36C77626B0009 EHRM Infrastructure Upgrades – Syracuse VAMC
Technical Questions and VA Response Tracking Sheet

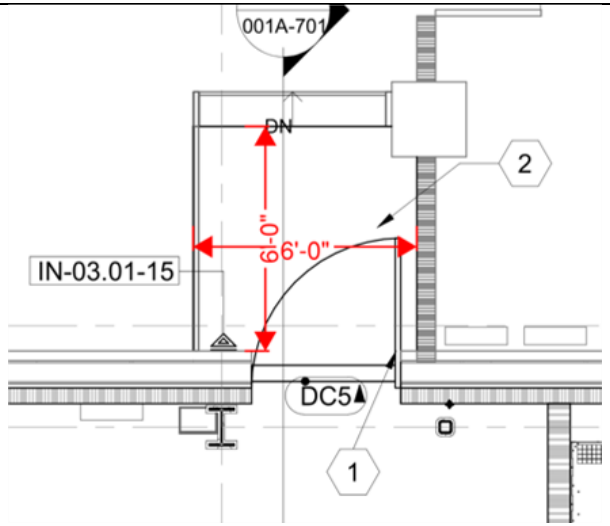
ITEM NO.	DATE QUESTION RECEIVED	QUESTION	GOVERNMENT RESPONSE
202.	3-20-26	Drawing 001A-405c – LVL 05 – UPS Floor Plan - Keynote 2 – please confirm location of detail for new conc. pan landing with stair & pipe railing.

See image. Size of landing also to be confirmed by minimum door clearances pending confirmed location of existing wall. Drawing snip provided for clarity. MN 4/17/26

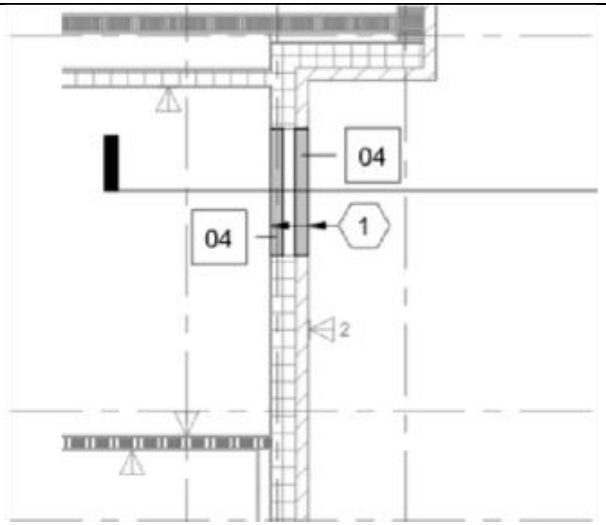
ITEM NO.	DATE QUESTION RECEIVED	QUESTION	GOVERNMENT RESPONSE
224.	3-20-26	Drawing 001A-406c – please confirm northernmost inside window wall type infill along col line L is wall type 5 and not wall type 4.

It is understood this is the window opening in question. It is not a rated wall and does not need wall type 5. MN 4/17/26
